AGENDA ITEM REPORT

ITEM: Review and discussion of Site Plan Application by 9201 West LLC to construct a 6 unit, 3- Story Multi-Family Development to be located at 9201 West Bay Harbor Drive. Enclosed are the Site Plans and the Staff Report prepared by Town Planner Michael Miller.

Subject: **Site Development Plan Application**
 Bay Harbor III Townhouses -5 DU Townhouse Complex
 9201 - 9241 West Bay Harbor Drive
 Bay Harbor Islands Acct. No. SPR22-00002
 MMPA Account No. 01-0702-1114

MMPA recommends the Development Review Committee (DRC) **DEFER** action on the proposed Site Development Plan application at this time to allow the applicant's design team to address the listed comments. The submittal package has several design / Code violation issues, some of the plans are inadequate or missing and a few other items need to be corrected.

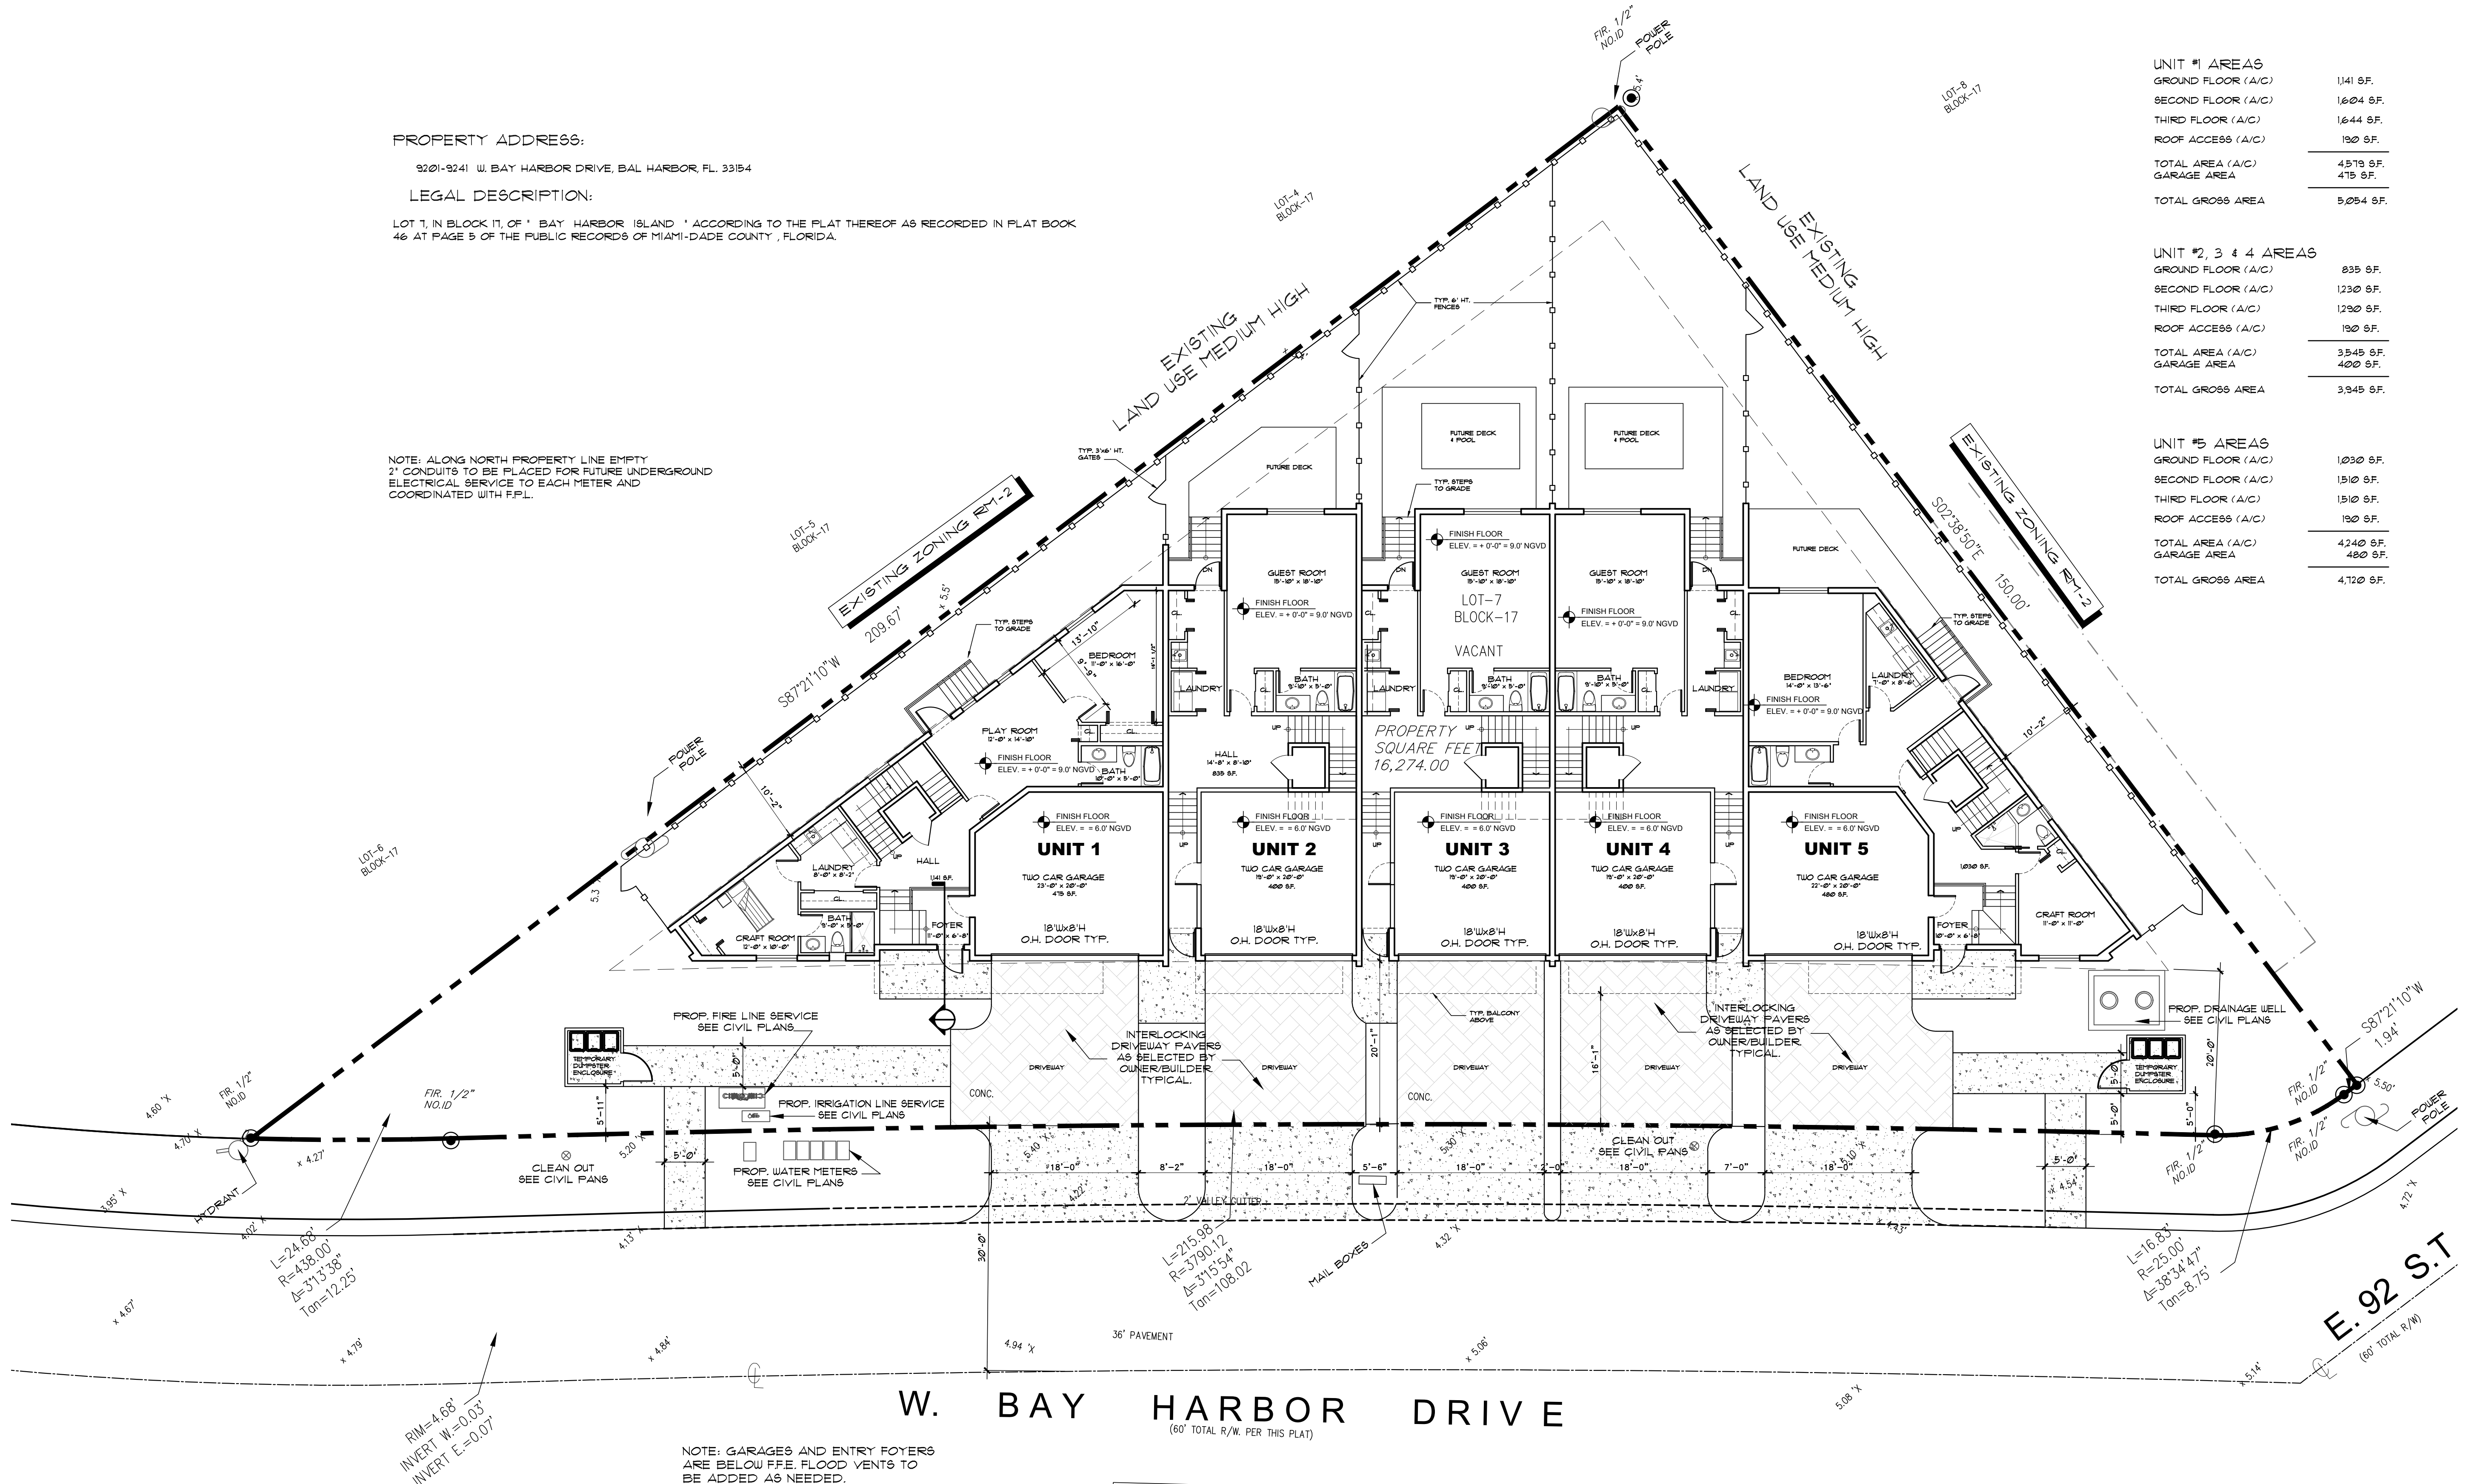
3. On Sheet SP-1 in the Site and Building Data Table the current plan notes that there will be only **11.88%** pervious open landscaped area in the design; however, a minimum of 20% is required per Code Sec. 23-11(82)(10). Oddly, the pre-DRC plans noted there would be 39.96% of the site as pervious landscaped open space. But the site plan layout appears similar. There appears to be major mathematical calculation errors in all of the data listed (building footprint / parking/ accessory / open space). If one sums all of the individual numbers, the total far exceeds 16,274 sq. ft. Please research and update the plans to at least comply with minimum open space Code criteria.

On Sheet SP-1 in the Parking Data Table the current plan notes state that 2 parking spaces per DU are required plus one (1) guest space = 11 spaces. But then the plan note states that only 10 spaces are provided. Zoning Code Sec. 23-24(c)(3) exempts townhouse developments with front entry garages / direct driveway connections from providing separate guest spaces - as the driveway serves that purpose. Revise the plans to note that only 2 parking spaces per DU is required / provided.

4. On Sheet SP-1 only partial ground floor use / elevation details are shown. The civil engineering plans have more details. At least add the FFE of the garages / other areas on Sheet SP-1. Confirm with the Bldg. Official that the ground level uses/ elevations are acceptable, and that adequate flood vents to the garages is provided as discussed at the pre-DRC meeting. Add the widths of the driveways on the site plan (18' min width).

PHOTOMETRIC PLAN

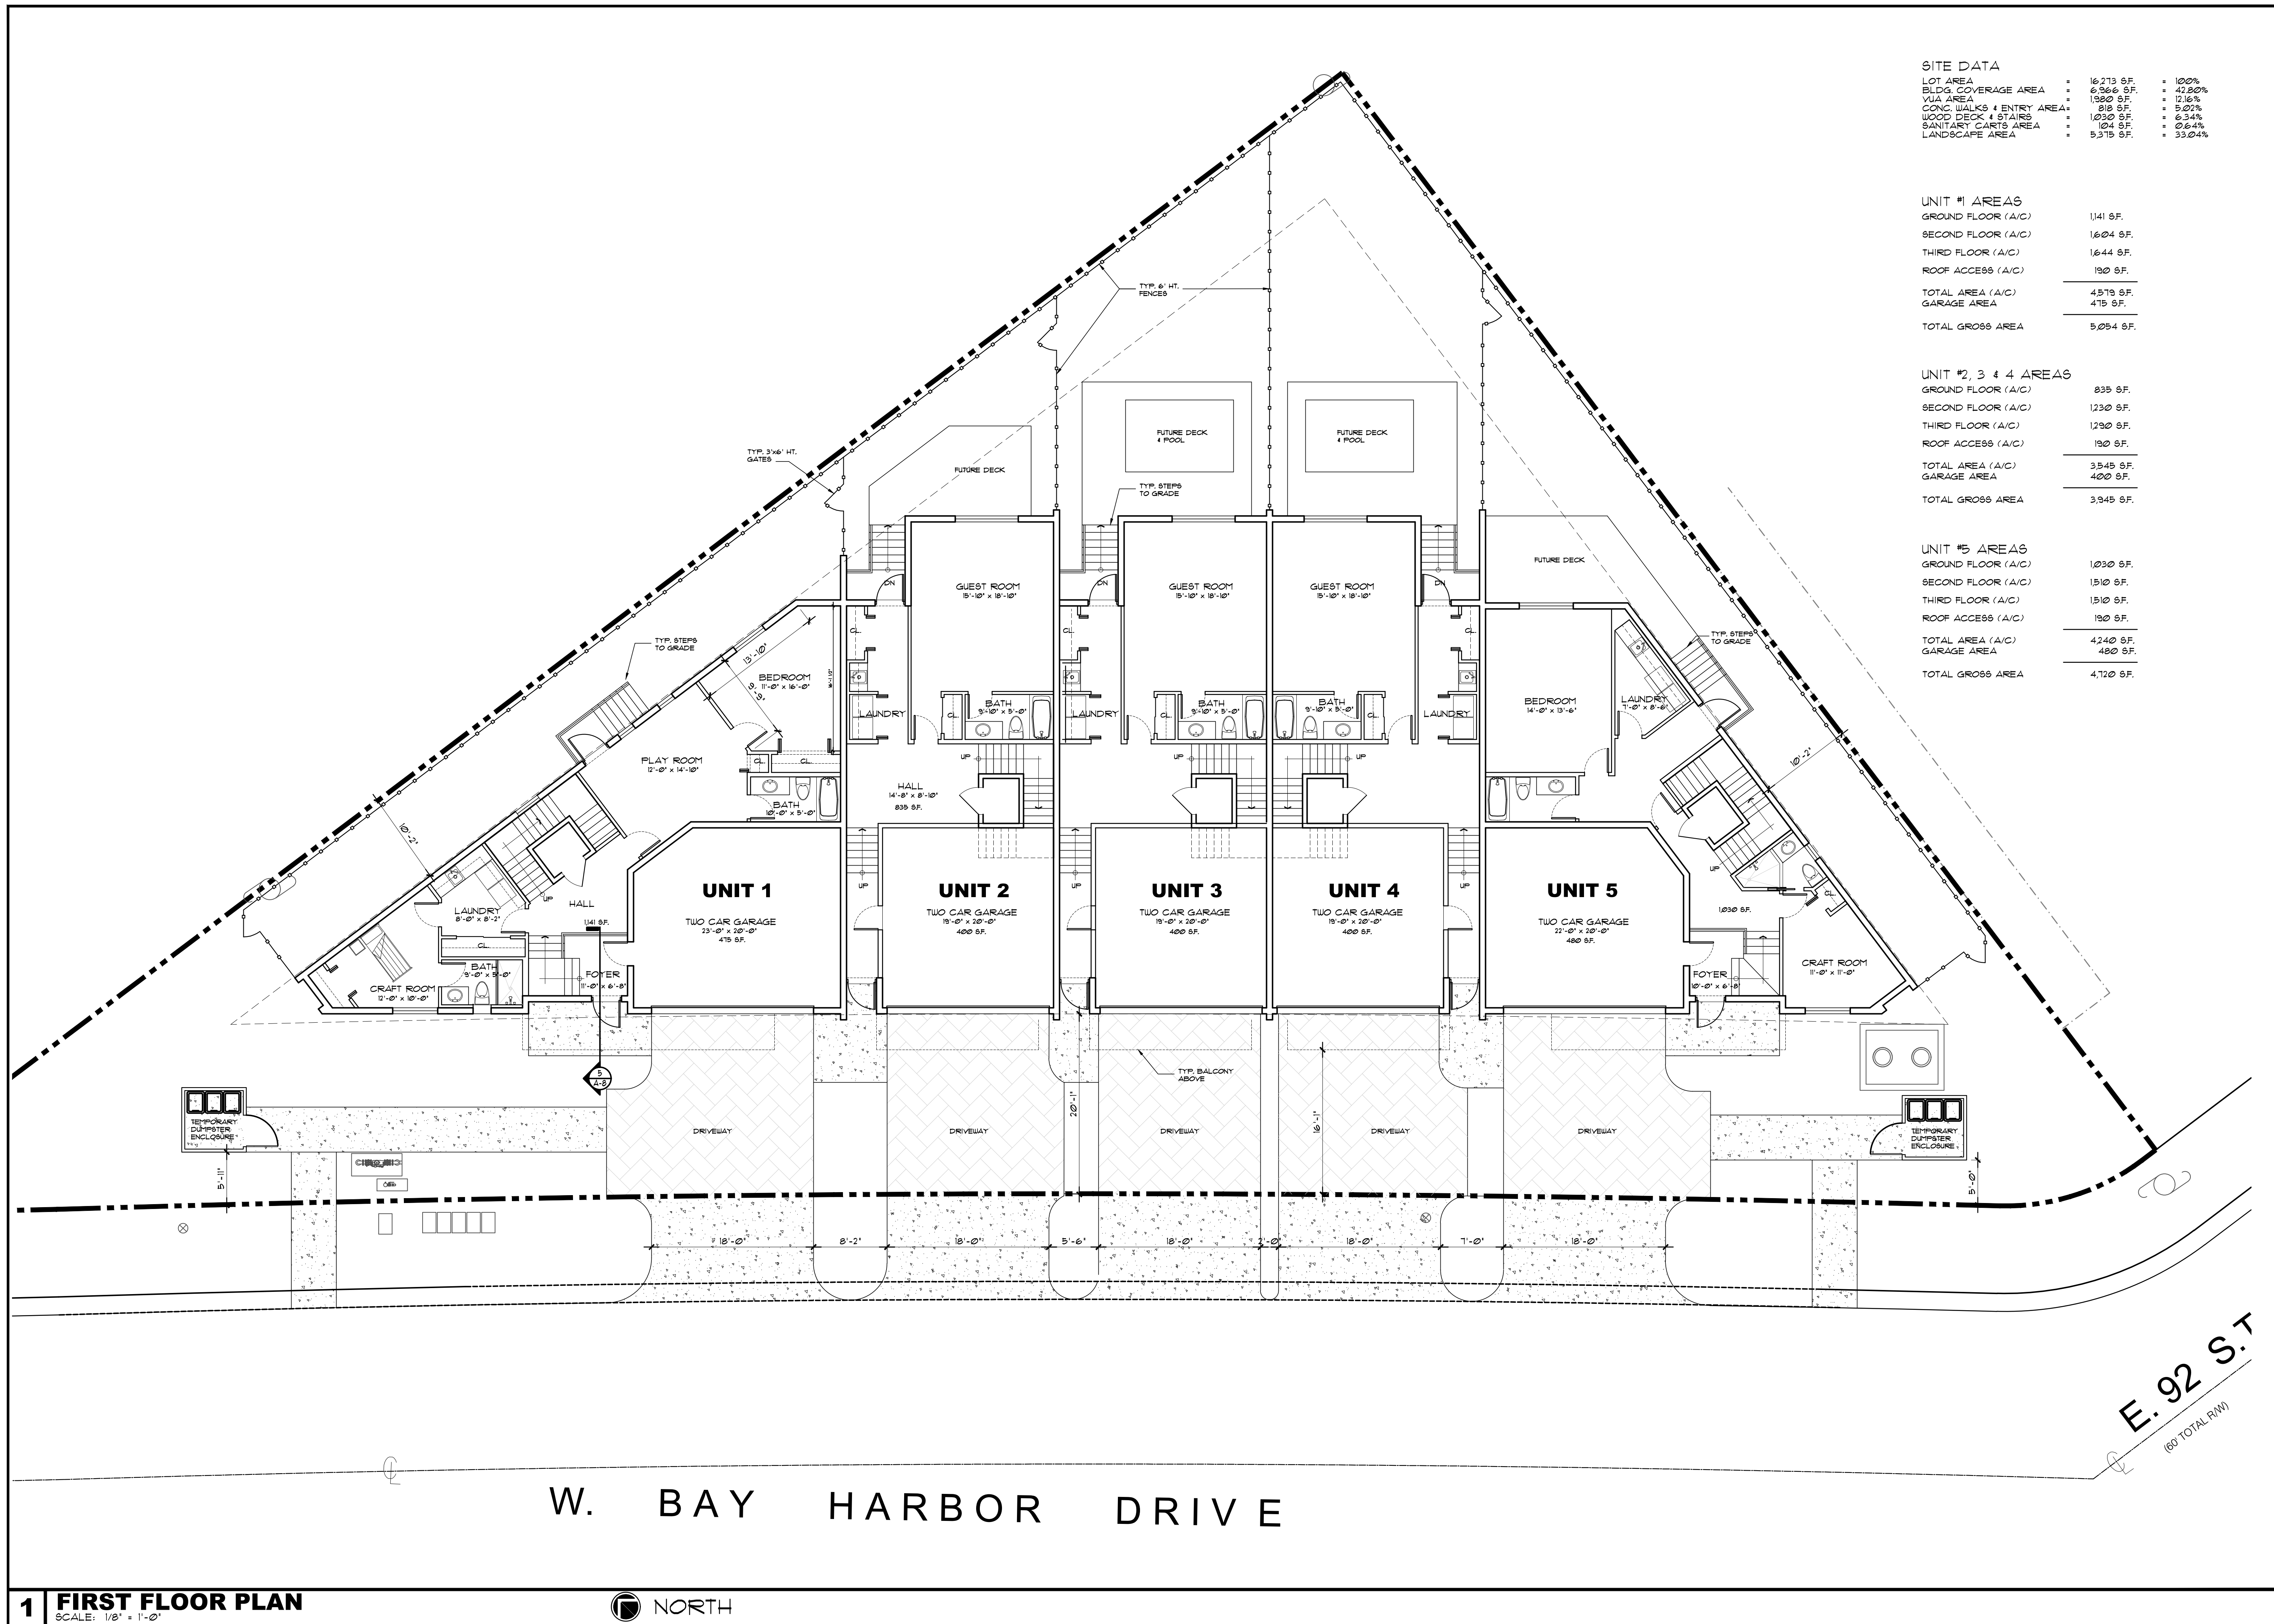
4. The preliminary Photometric Plan presented on Sheet PH-1 is only for the ground level areas and only indicates potential footcandle readings between the front of the building and street. This plan is incomplete as it must include preliminary footcandle readings for the entire site. The Town's Outdoor Lighting Code is found in Sec. 23-19 and includes Table 1 describing the minimum / average / maximum allowed footcandle readings for various areas of a site. A preliminary Photometric Plan is required for the entire site as part of the Site Development Plan submission and include the building rooftop as well if it is used for activity. The Town has had complaints about excessive lighting on new redevelopment projects – most likely due to modern / brighter LED light fixtures. In the north rear yards of this site / rooftop excessive bright lights may negatively impact the adjoining residential complexes. Revise / provide the missing documents.
